UNITED STATES PATENT AND TRADEMARK OFFICE

Office Action Summary	Application No. 10/605,852	Applicant(s) WEISS, MARTIN	
	Examiner Vinh T. Luong	Art Unit 3682

5. The text of those sections of Title 35, U.S. Code not included in this action can be found in a prior Office action.
6. Claims 15-18, 21, 22, and 25 are rejected under 35 U.S.C. 102(b) as being anticipated by Yamashita (US Patent No. 5,946,978).

Fig. 3

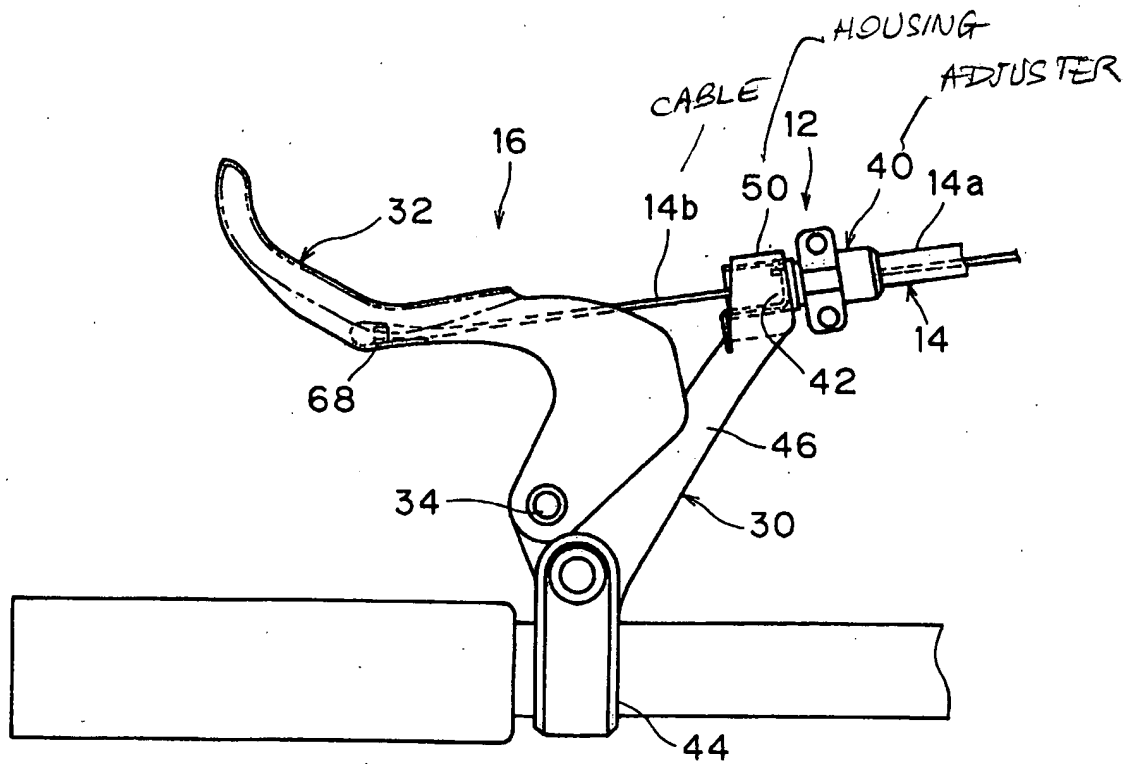
Regarding claim 16, the detent contour 80 has a non-round cross section (FIG. 5) and is configured such that the retention segment 95 has freedom to deflect, the retention segment 95 is configured to extend substantially parallel with the control cable 14b extending through the adjuster 40 (see FIG. 3 in Att.).

Fig. 5

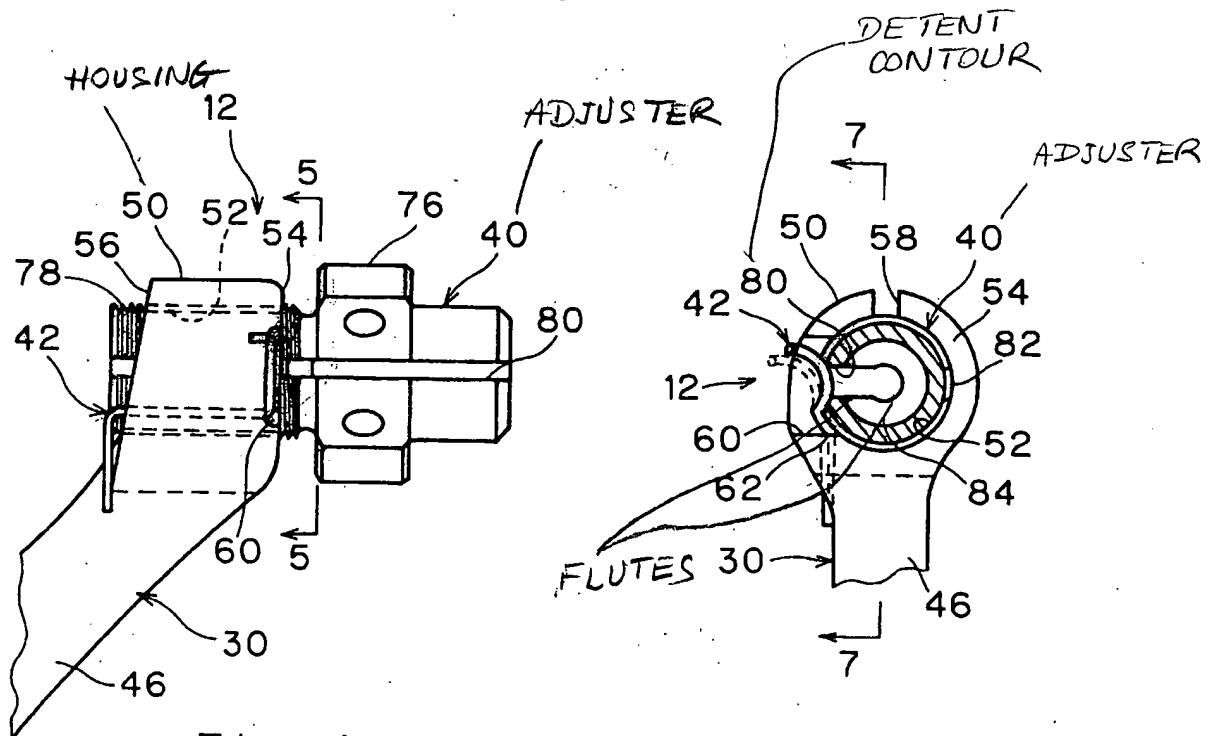
Regarding claim 17, the detent contour 80 includes varying surfaces (FIG. 5) configured to engage the retention segment 95 such that rotation of the adjuster 40 in a first direction inherently requires a higher rotational force than rotation of the adjuster 40 in a second direction.

Fig. 7

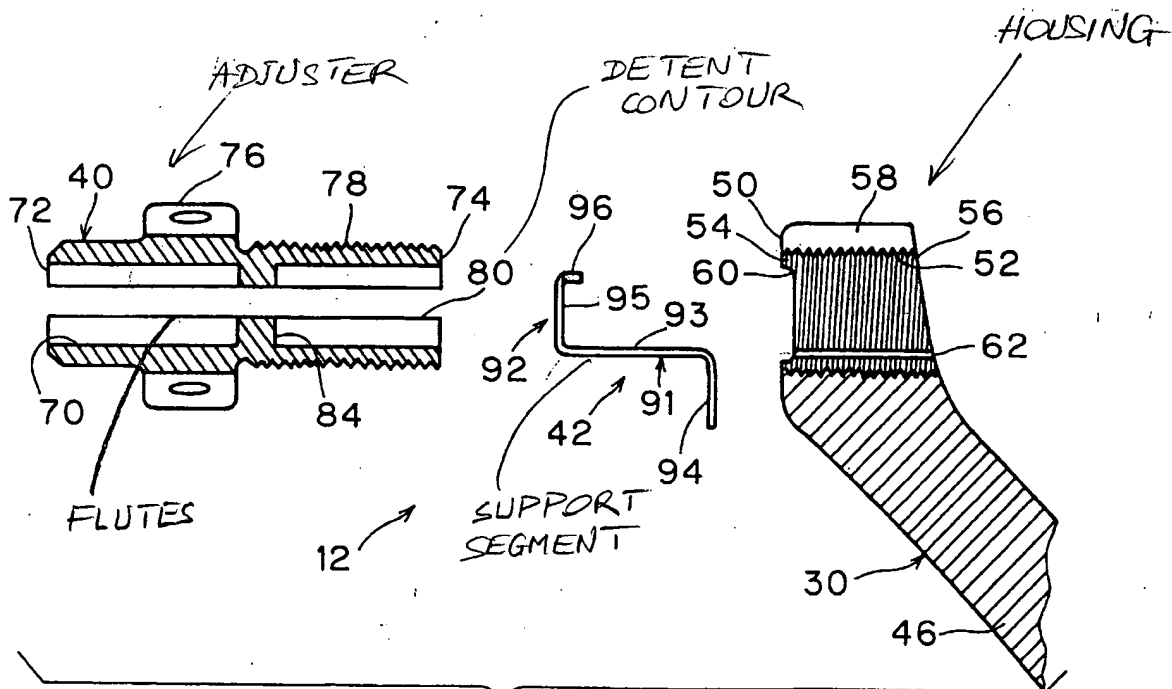
a detent mechanism including a detent contour 80 (see Attachment hereinafter "Att.") extending along a radial interior surface (FIG. 7) of the adjuster 40 and a spring element 42 having at least one retention segment 95 (FIG. 10) and a support segment 93, the retention segment 95 of the spring element 42 engaging the detent contour 80 (*id.* col. 6, lines 53-64), the support segment 93 of the spring element 42 supported by the housing 50 (FIG. 4). *Ibid.*, claims 1-17.
